BEFORE THE PUBLIC SERVICE COMMISSION OF UTAH

IN THE MATTER OF PACIFICORP'S 2021 INTEGRATED RESOURCE PLAN	Docket No. 21-035-09
--	----------------------

REDACTED COMMENTS OF WESTERN RESOURCE ADVOCATES

March 4, 2022

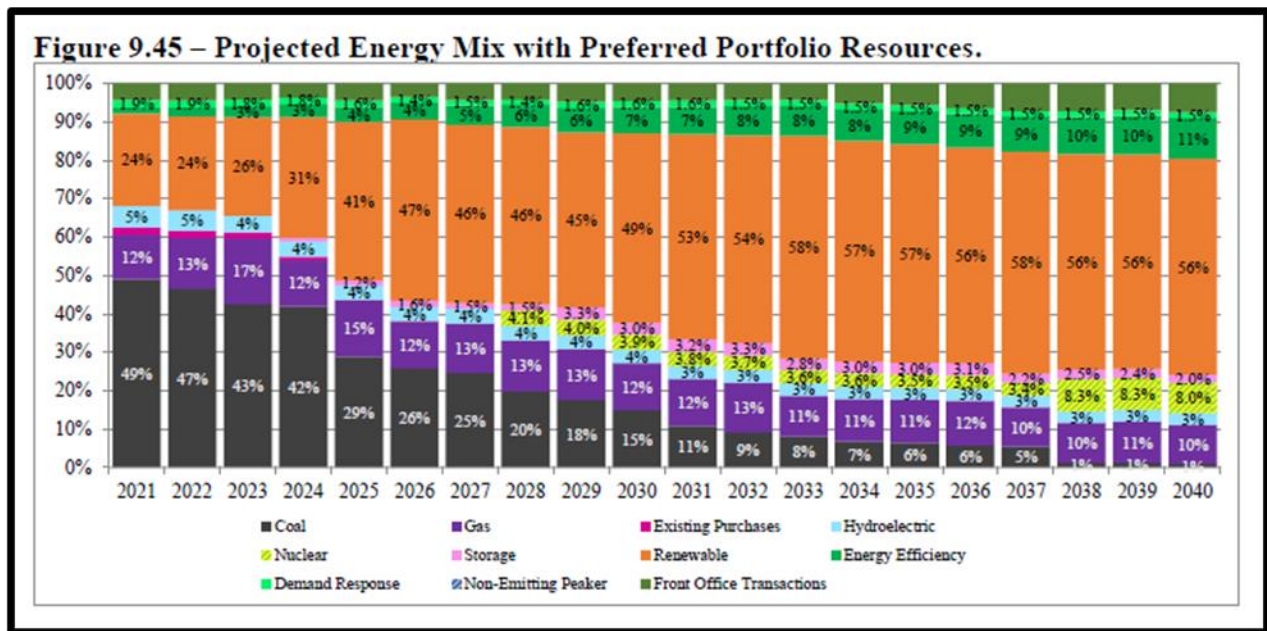
Regarding PacifiCorp’s Figure 9.45, PacifiCorp explained that the renewable energy information (in orange) is based on “categorization by technology type and *not disposition of renewable energy attributes.*”⁴⁶ In a footnote, PacifiCorp further explained,

In other words, the energy labeled as “renewable” in the Figure may not actually represent renewable energy; rather, it may represent null power.

WRA requests that the Commission require PacifiCorp to provide additional information about the distinction between renewable energy and “null power” (defined below) in future resource plans.
